Re; Plot Nos; 7 & 8 M.M.7 Machi Miani Qr;

PLAN SHOWING UNAUTHORIZED WORK CARRIED OUT
ON PLOT No 7 & 8, SHEET M.M-7 MACHI MIANI Q.R.
SCALE 8:1

1. Rooms have no through ventilation.
2. Drainage lines should be shown on the plan.
3. Site plan is wrong (plot Nos. 7 & 8 are separate plots).
4. correct alignment to be shown.
5. width of street to be shown.
6. Area of the plot to be shown.
7. Plan is incorrect as to the no. of rooms open space etc. It is also incomplete as regards details of construction.
8. Since the plan is for work unauthorizedly carried out only such work must be shown and not new proposals.
9. The whole structure is old and in a dilapidated condition and walls are tottering and the flooring & roof is weak and the stairs also.
10. The internal open space is inadequate and the rear rooms have no ventilation and are unfit for living purposes.
11. The unauthorized stone masonry walls are shown resting on foundations whose dimensions must be completely given and the same will have to be verified at site.

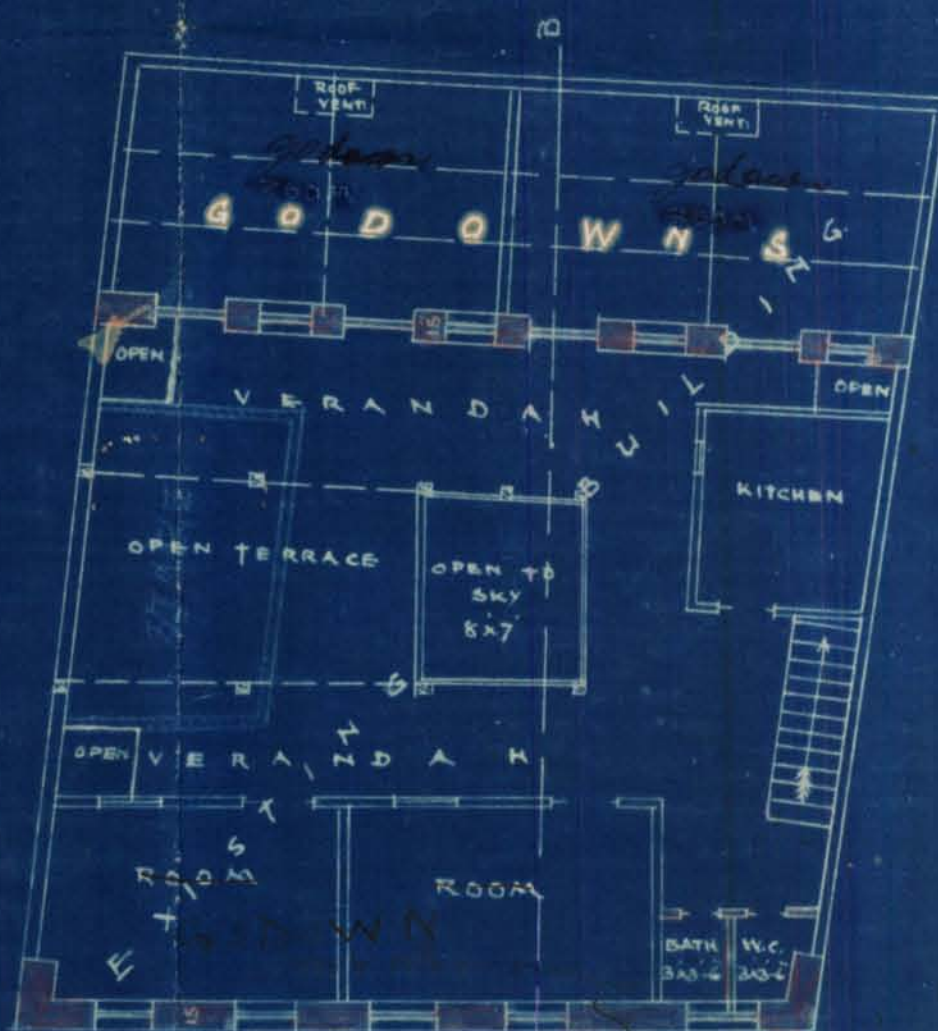
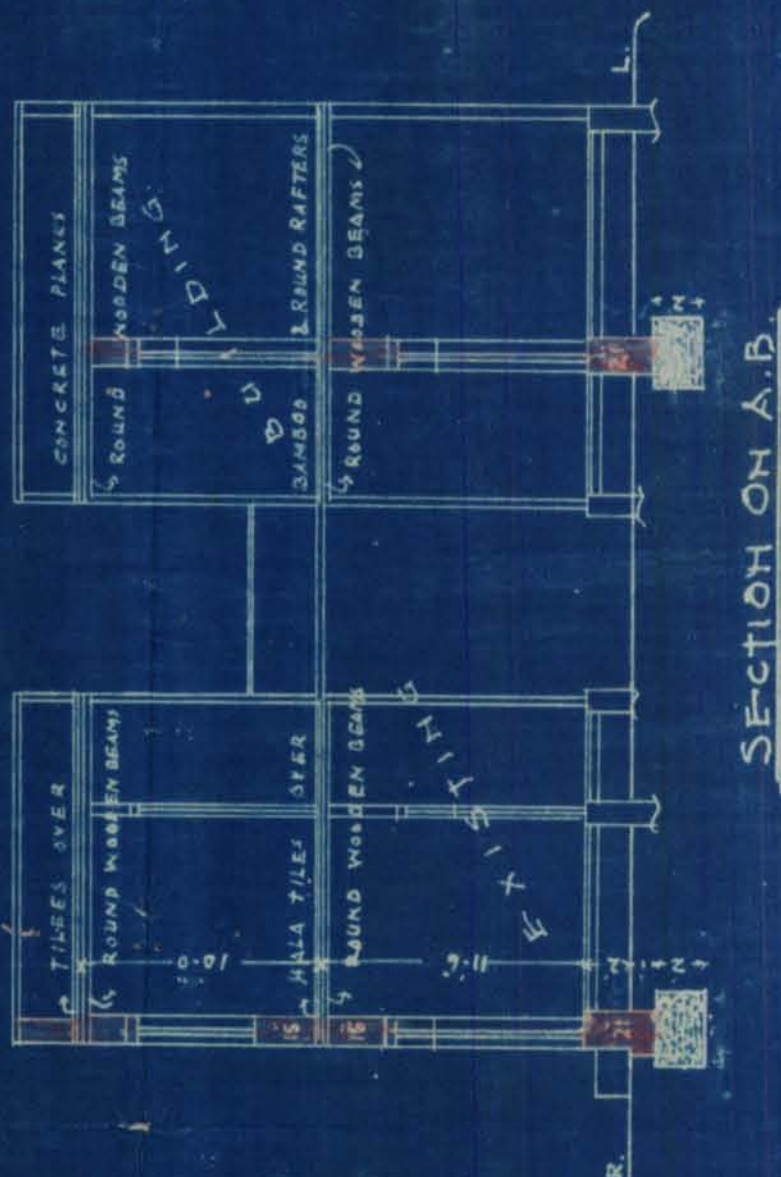
Notes:
Plan showing unauthorized work carried out on Plot No 7 & 8, Sheet M.M-7 Machi Miani Q.R. The work consists of the construction of a Godown for dry fruit on Plot No 7 and a Godown for dry fruit on Plot No 8. The work is unauthorized and is in violation of the provisions of the Town Planning Act, 1919 and the Town Planning Regulations, 1925. The work is to be removed at the expense of the owner.

PLAN SHOWING UNAUTHORIZED WORK CARRIED OUT
ON PLOT No 7 & 8, SHEET M.M-7 MALCHI MIANI QR.
SCALE 8=1

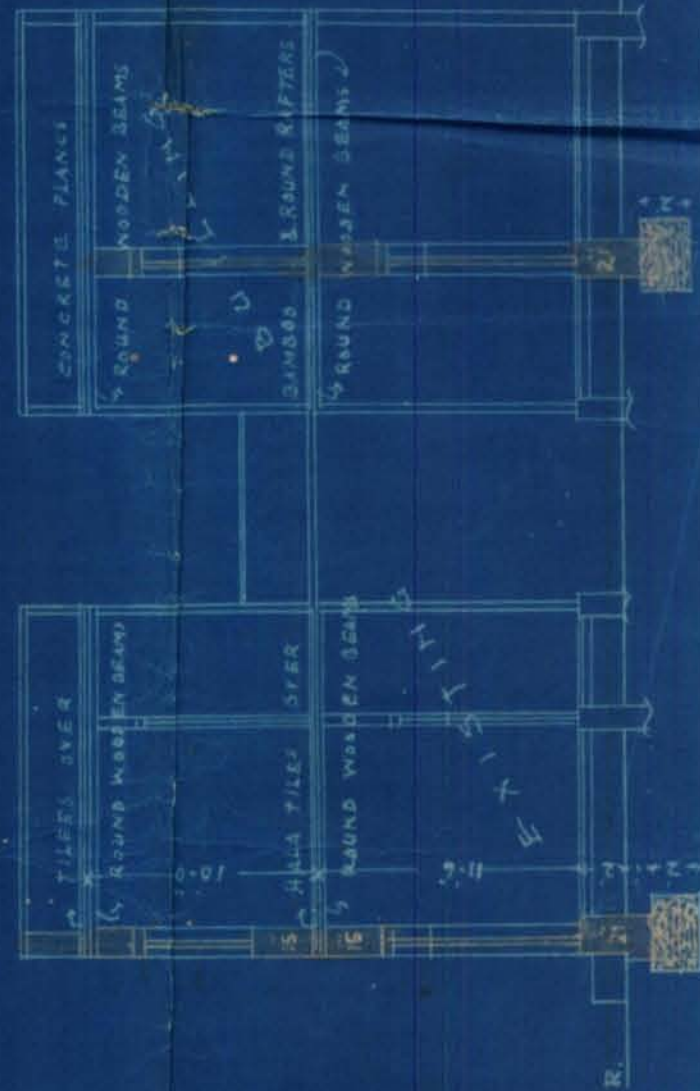
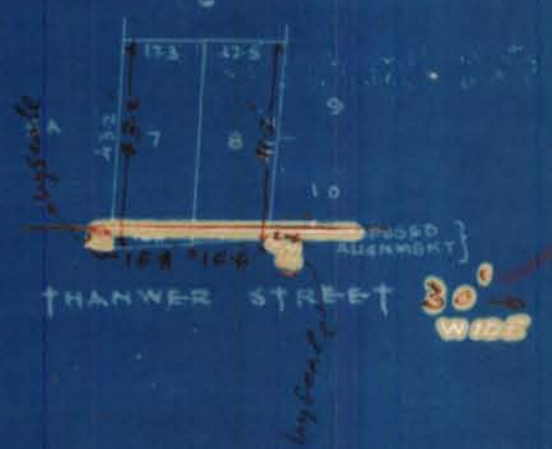
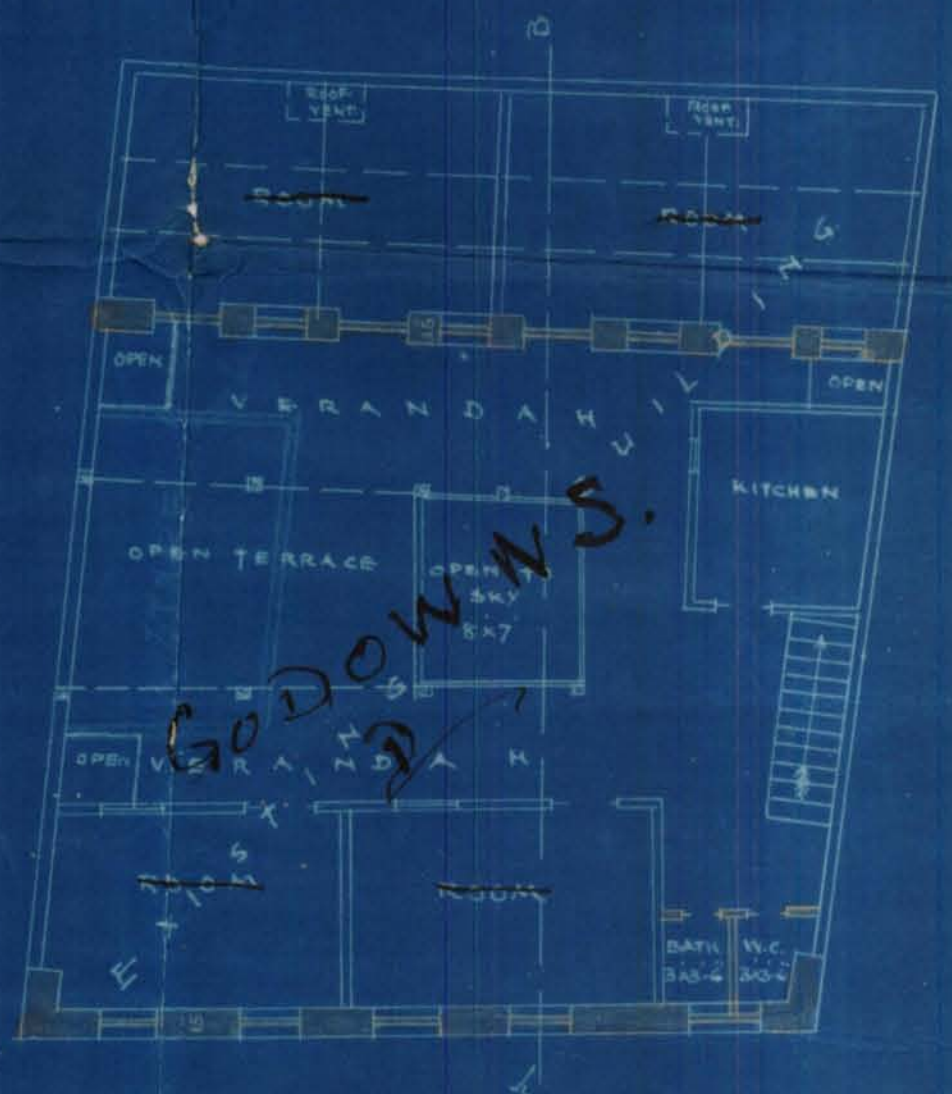
Plans to be corrected by showing godowns instead of
rooms on the 1st floor as on ground floor.

1. Objection No. 1 of this office letter dated 31st August 1937 hold good

PLAN SHOWING UNAUTHORIZED WORK CARRIED OUT
ON PLOT No 7 & 8, SHEET M M-7 MACHI MIANI QR:
SCALE-8=1"

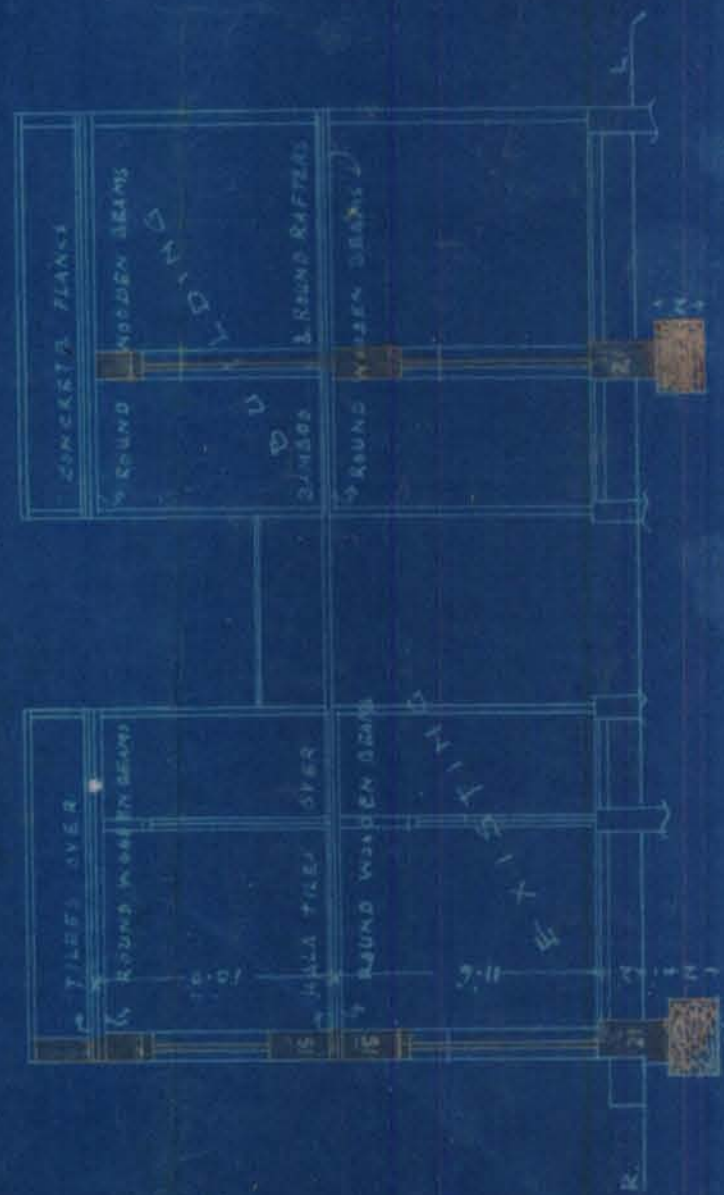
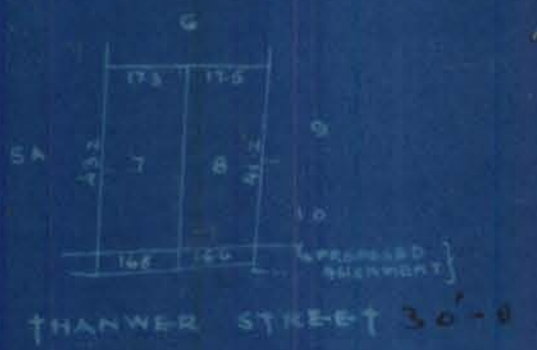
1. Plan is incorrect as to the no. of rooms open space etc. It is also incomplete as regards details of construction
2. Since this plan is for work unauthorizely carried out any such work must be shown and not new proposals.
3. The whole structure is old ^{and in a} dilapidated condition. ^{flooring and} walls are tottering and the roof is weak & the stairs also.
4. The internal open space is inadequate and the rear rooms have no ventilation and are unfit for living purposes.
5. The unauthorized stone masonry walls are shown resting on foundations whose dimensions must be completely given and the same will have to be verified at site.

- (1) Site Plan is wrong, (Plot nos 748 are separate plots)
(2) Correct alignment to be shown.
(3) Width of street to be shown.
(4) Area of the plot to be shown.

Drainage lines should be
shown on the plan.

Rooms have in Through Ventilation

1. In the already existing building the only possibility of providing ventilation in by providing roof ventilation ~~has~~ and this we have done. building we may mention is to be used only as a godown for storing dry fruit such we hope your requirement is quite satisfied.

2. Drainage line has been shown on the plan.
3. The plan is for an existing building on both plots and as alternative but to send a site plan for both the plots.

4. Correct alignment has been shown.
5. Width of the street is also shown.
6. Area of both plots Nos. 7 & 8 is shown.
- 7 & 8. The plan has been submitted showing the final shape, the house is go take and since the work is to be immediately carried out there would seem to necessity for sending two separate plans.

9. All the weak portions of the building are sought to be repaired or as the need be as soon as the plans are approved.
10. We have mentioned in the plan that the premises are require godown for storing Dry fruit, and we hope in view of this fact require not arise, since the house is not to be used for living purposes.
